# Central Planning Authority

**Agenda** for a meeting of the Central Planning Authority to be held on **28 August 2024 at 10:00am** in Conference Room 1038, 1st Floor, Government Administration Building, 133 Elgin Avenue

CPA/22/24

## Gazette Plans for EWA Extension and Agricola Drive - Impact on 31A164 and 31A16

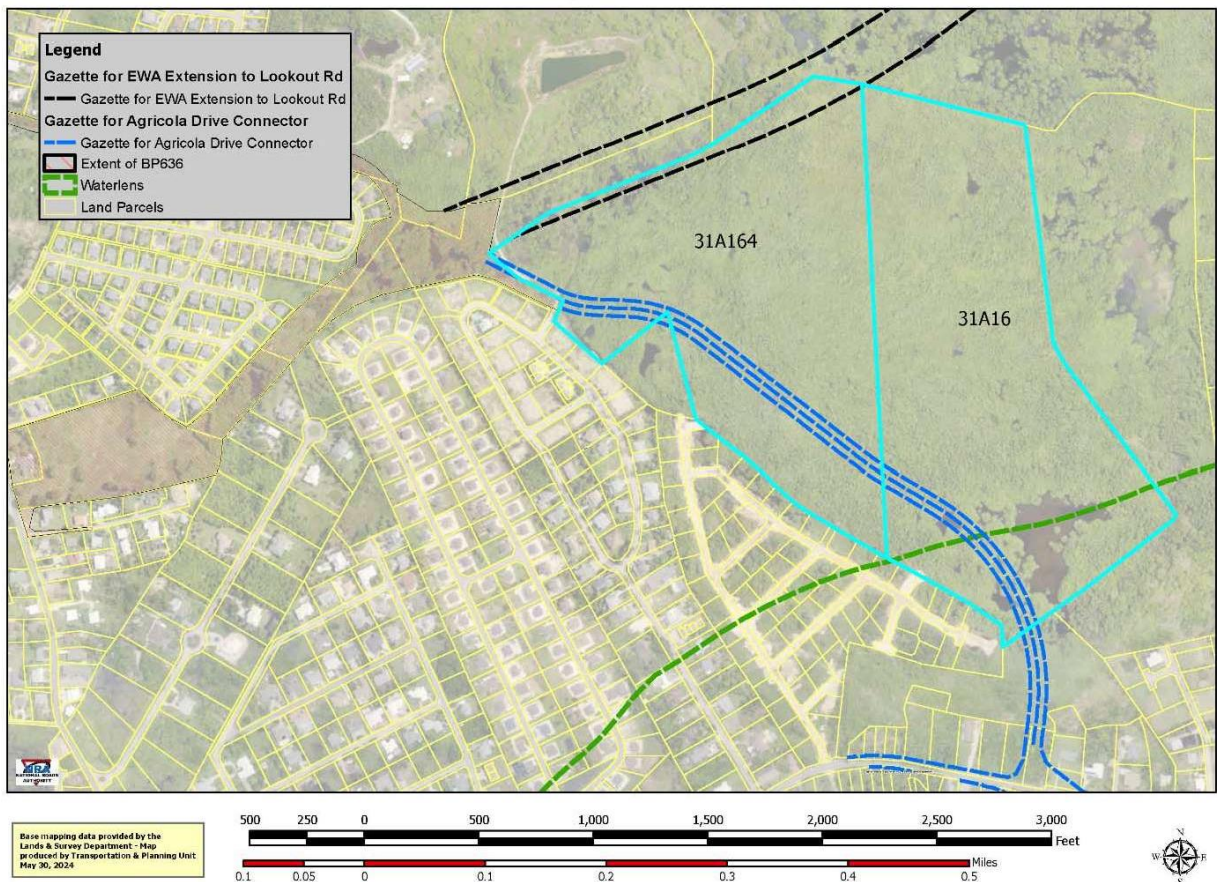
*Additionally, while the Environmental Impact Study (EIA) for the extension of the East-West Arterial corridor from Woodland Drive to Frank Sound Road is still on-going, the alignment and width of this planned road corridor is now essentially been set at 220 feet —the findings of the EIA study should be completed as a Draft Environmental Statement by end of the summer where the public will have an opportunity to comments on the EIA at public meetings. For the CPA's and the applicant's benefit, the alignment of the extension of the EWA corridor along with the Agricola Drive connector roadway are depicted on the following map.*

**The configuration of the new intersection between the EWA extension and Agricola Drive is still being assessed and determined by the Engineering Section of the NRA. On that basis, the NRA indicates to the CPA that these details can be finalized at a future phase of the subdivision plan.**

**Figure 1: UK Hydrographic Office 2021 aerial image showing the subject parcels highlighted in light blue. Note that the parcels consist of seasonally flooded mangrove forests and woodland. The filling of this habitat has the potential to impact surrounding residential areas.**

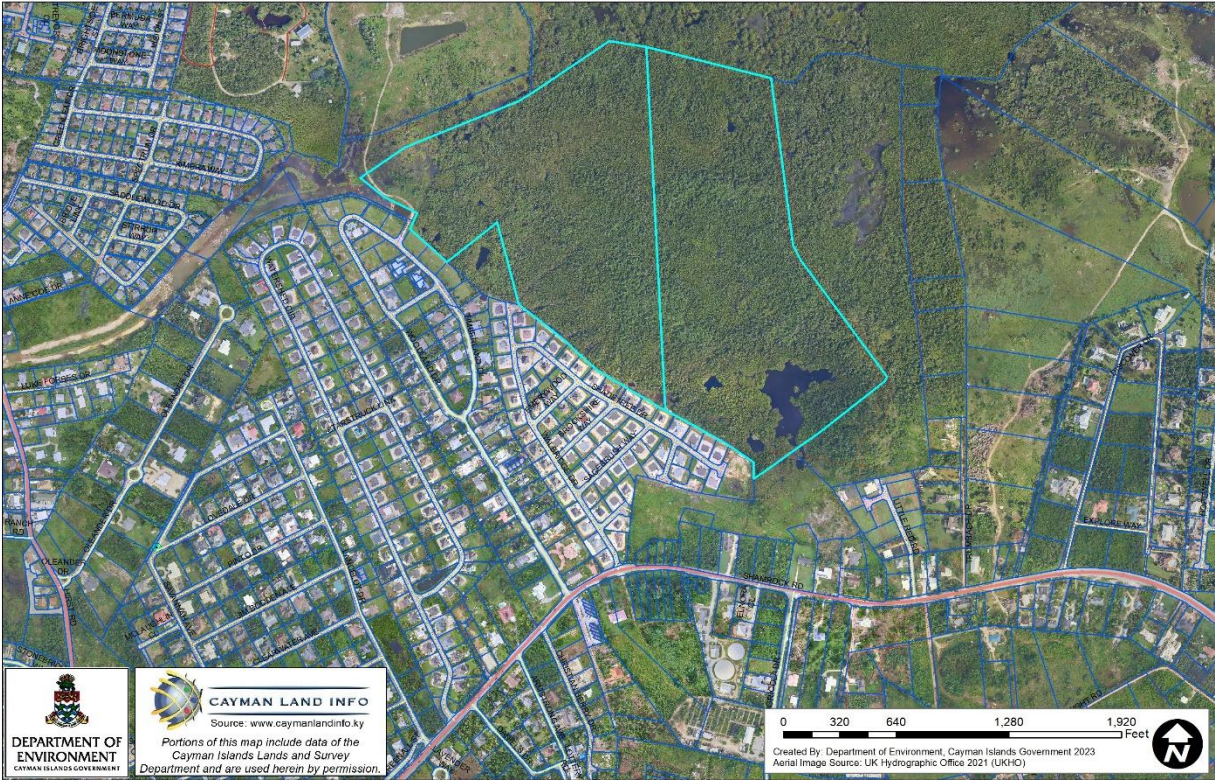
*We note that the proposed subdivision plan references the East-West Arterial road and Savannah By-Pass Connector (shown as "Proposed NRA take" on the applicant's site plan). The East-West Arterial road is currently the subject of an ongoing Environmental Impact Assessment (EIA), due to the potential effects on flooding and drainage of nearby communities and the hydrology and ecology of the Central Mangrove Wetlands. The EIA will help to refine the specific route of the road and will determine the design required to maintain a suitable hydrological regime. The outcome of the EIA also has the potential to affect current and proposed land-use along the road corridor; for example, the EIA may recommend stormwater management techniques such as the requirement of retention ponds in specific areas.*

*The applicant’s site plan shows the retention of an existing pond on-site on Block 31A Parcel 16. In future, it will be essential to ensure that stormwater does not run off into the pond as this could lead to eutrophication of the pond and associated poor water quality impacts and amenity issues. Ponds can also be susceptible to contamination from neighbouring septic tanks and the use of fertilizer during landscaping maintenance.*

*Figure 1: Extract taken from Cayman Land Info's Digital Terrain Model 2018 showing the natural elevation of the application site which is outlined in red.*

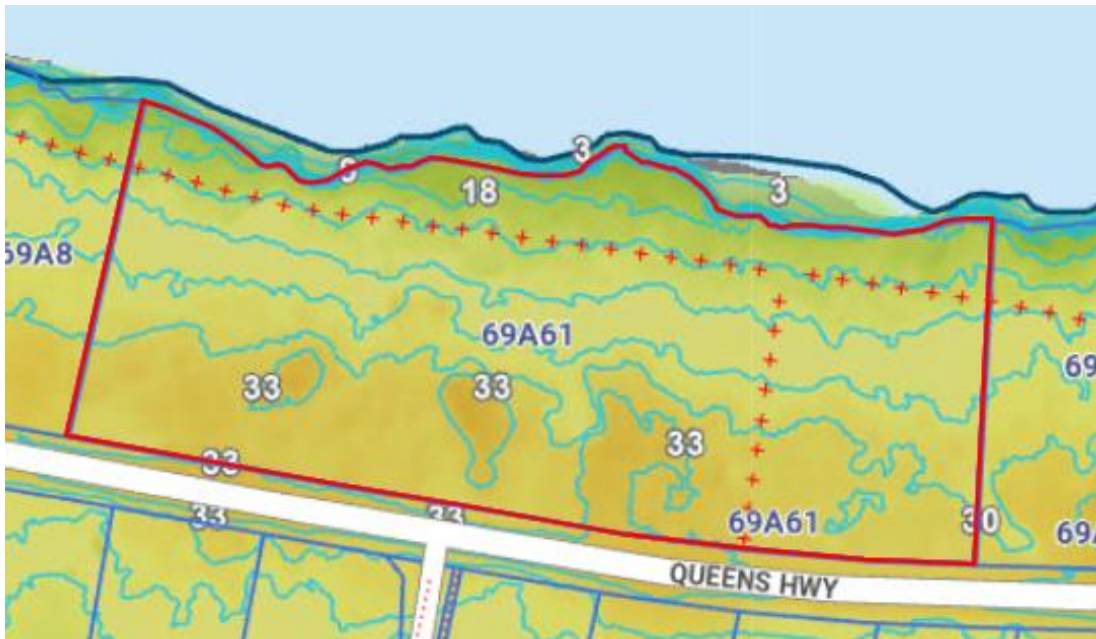
*The application site is located on a highly elevated coastal ridge (Figure 1), adjacent to a Marine Reserve (a Protected Area under the National Conservation Act) and is located on a Scenic Coastline. The site also consists predominately of a mixture of primary coastal shrubland, dry forest and dry shrubland. Primary habitat is mature habitat in its natural state, otherwise uninfluenced by human activity where ecological processes are not significantly disturbed. These habitats are often very old, existing long before humans and may consist of many endemic and ecologically important species. Primary habitat is in severe decline and becoming a scarce and highly threatened resource as a result of land conversion for human activities.*
